Rezoning Transportation Analysis

Petition Number: 2025-126

Date	Description
12-22-25	First Review (BH)
01-14-26	Trip Generation Update (DR)
01-28-26	Second Review (BH)

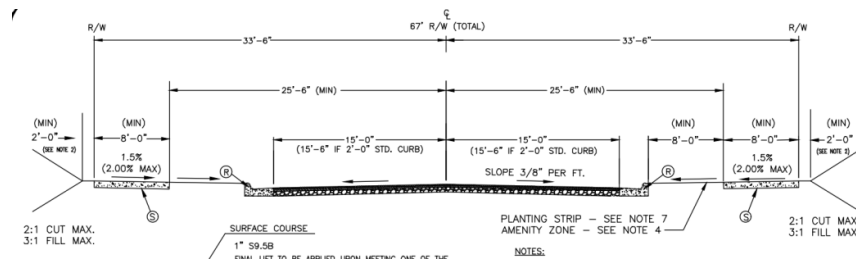
- a. **Wilora Lake Road:** Location of future back of curb and gutter is to be located 17.5 feet from road centerline and must be shown in the future location according to UDO Article 32.7 and 2040 Policy Map.

Local Residential Wide typical section with 8' sidewalk (CLDSM Standard No U-03A1).

Label and dimension the curb and gutter form the centerline for each road on the site plan.

Comment Rescinded 01-28-26: Please remove on-street parking from Wilora Lake Road and existing curb is to remain in place.

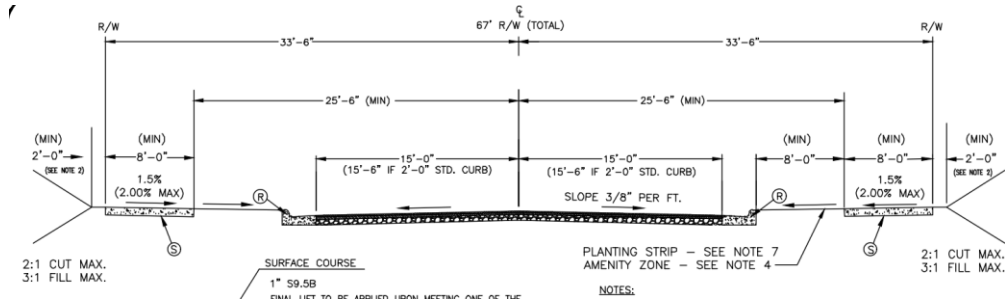
- b. ~~Mayberry Lane~~: Location of future back of curb and gutter is to be located 17.5 feet from road centerline and must be shown in the future location according to UDO Article 32.7 and 2040 Policy Map.

~~Local Residential Wide typical section with 8' sidewalk (CLDSM Standard No U-03A1).~~

~~Label and dimension the curb and gutter form the centerline for each road on the site plan.~~

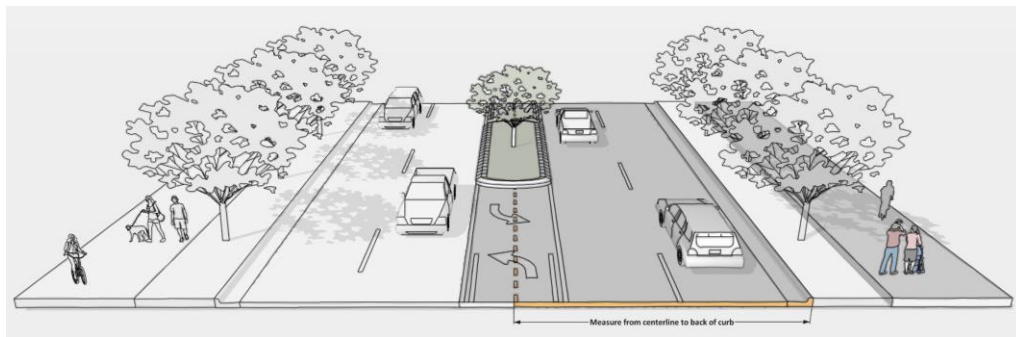
- c. ~~N Sharon Amity Road~~: Location of future back of curb and gutter is to be located 30 feet from road centerline, and must be shown in the future location according to UDO Article 32.7 and 2040 Policy Map. Existing curb may remain in its current location.

~~Arterial 4+ Avenue with Shared Use Path (Charlotte Streets Map).~~

~~Label and dimension the existing and future curb and gutter form the centerline for each road on the site plan.~~

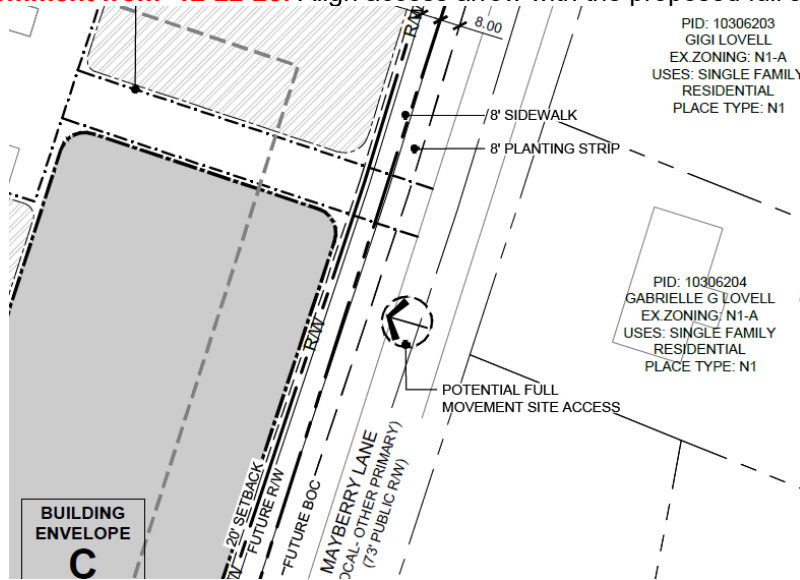
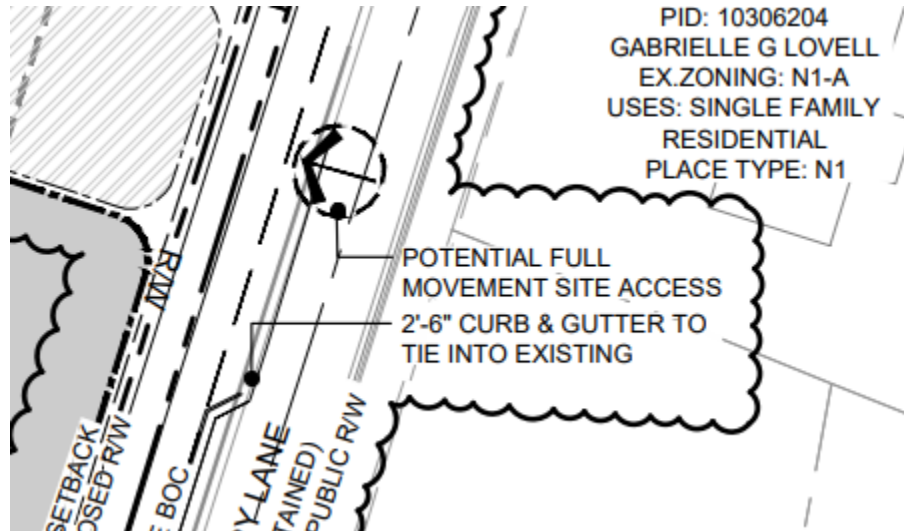
8. **Outstanding Comment from 12-22-25:** Align access arrow with the proposed full access location.

Clarifying comment 01-27-26: Clarify location or remove "potential full movement site access" from Mayberry Lane.

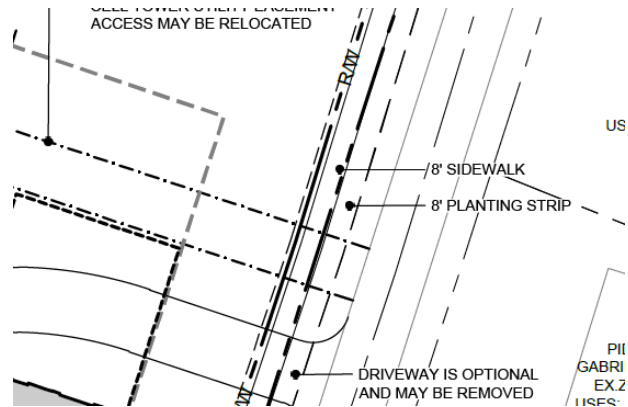
9. **Outstanding comment from 12-22-25:** Clarify how the proposed cell tower utility easement is being accessed from Mayberry Lane.

10. Clarify what this area is that has the access shown going through it.
